URGENT – Field Safety Notice

CombiDiagnost R90/ProxiDiagnost N90
Missing Warning Labels

October 2021

Figure 1. Label Locations

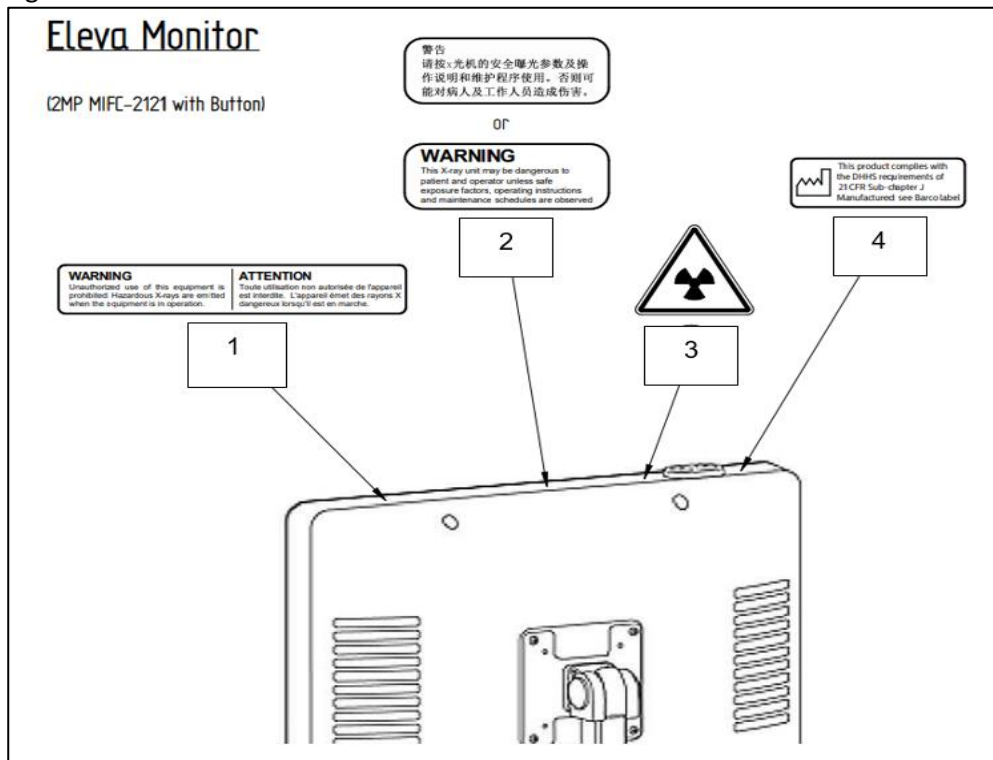
X-ray warning label(s) are missing from the Eleva Examination Console on CombiDiagnost C90 and ProxiDiagnost N90 systems. Regulations require that these labels be affixed to the system. The location and content of where the labels should be affixed are shown in Figure 1 and Table 1.

A Philips Field Service Engineer (FSE) will visit your site to check for the required labels and if they are missing, will resolve the issue by applying the required labels on your CombiDiagnost R90 and ProxiDiagnost N90 system(s).
